Re: Racecourse Park Baldoyle JP06F.311315

I refer to the above application and wish to make the following observations.

Photo: Alan Downey

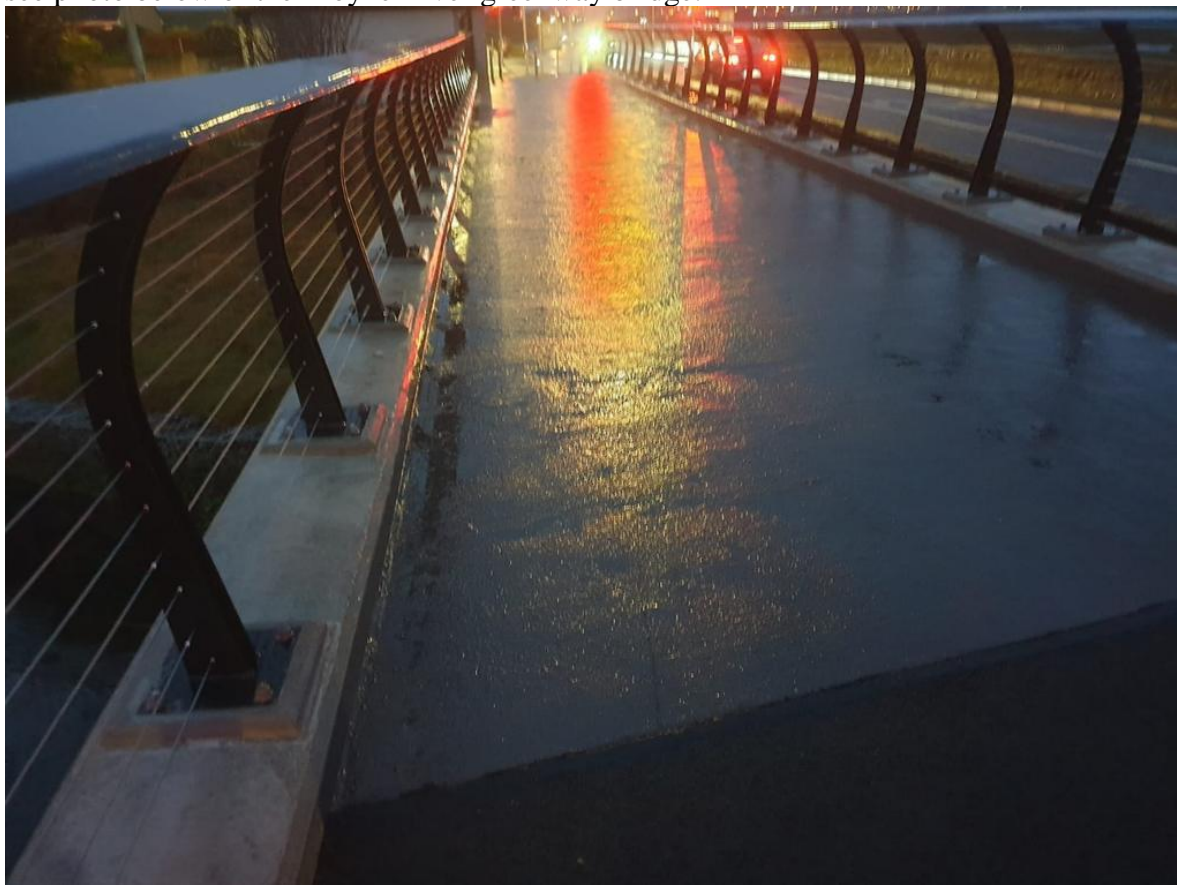
I note that it is proposed to provide steel bridges. The existing greenway bridge across the Moyne River forms a very slippery layer of ice on frosty nights. The Council to date has not, despite requests, been willing to include this location or other pedestrian bridges in its gritting programme. I urge the Board to either specify a surface that will not be slippery in all weather conditions, or to require gritting as part of the ongoing maintenance of these bridges. Please see photo below of the Moyne River greenway bridge.
